2965 Kingston Road to 3049 Kingston Road Site Plan Control Application – Final Report

Date:	June 9, 2015
To:	Scarborough Community Council
From:	Director, Community Planning, Scarborough District
Wards:	Ward 36 – Scarborough Southwest
Reference Number:	14 189038 ESC 36 SA

Site Plan Application Number: 14 189038 ESC 36 SA
Municipal Address: 2965 to 3049 Kingston Road (Cliffcrest Plaza)

Site Plan

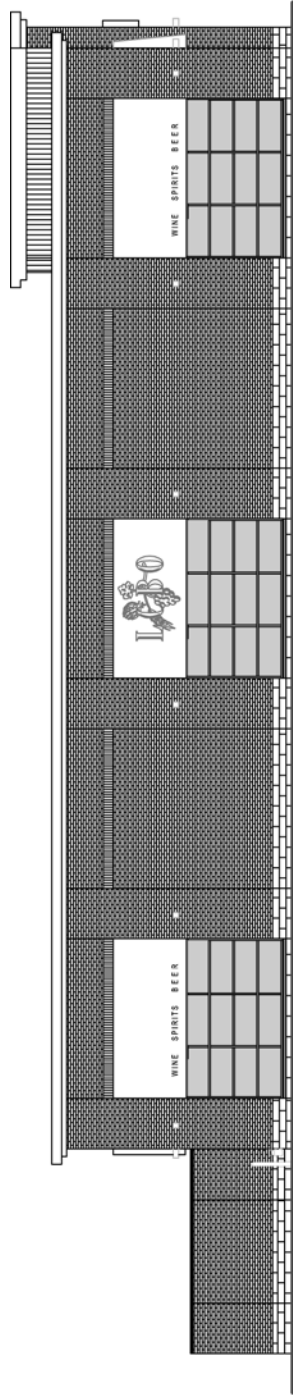
1. The Owner shall revise the Site Plan, Drawing No. A1-23, prepared by Turner Fleischer, Revision No. 3, dated February 24, 2015; and Overall Site Plan, Drawing No. A1-23.1, prepared by Turner Fleischer, Revision No. 5, dated February 24, 2015 as follows:

- (a) The first driveway on Cathedral Bluffs Drive south of Kingston Road must be reconstructed in accordance with the City of Toronto T-310.010 standard detail and must provide flared curb returns. This notation must be placed at this driveway entrance on all plans indicating this requirement.

- (b) All drawings including the Functional Plan must be revised to reflect the driveway details indicated on the overall Site Plan drawing no. A1-23.1.

- (c) The drawing must clearly denote that the Cathedral Bluffs Drive easterly curb is to be relocated and the pavement to be widened. The drawing must clearly indicate the extent of the works to Cathedral Bluffs Drive and reference the detailed engineering drawing that addresses the proposed work. To satisfy this requirement, a note must be added to the drawing portion of the Site Plan and Overall Site Plan and must reference the drawings which detail this work.

- (d) The revised Site Plan and Overall Site Plan must clearly illustrate and label that the existing municipal sidewalks along both Cathedral Bluffs Drive and Kingston Road will be removed and replaced with new municipal sidewalks. To satisfy this requirement, a note must be added to the drawing portion of the Site Plan and Overall Site Plan and must reference the drawings which detail this work.
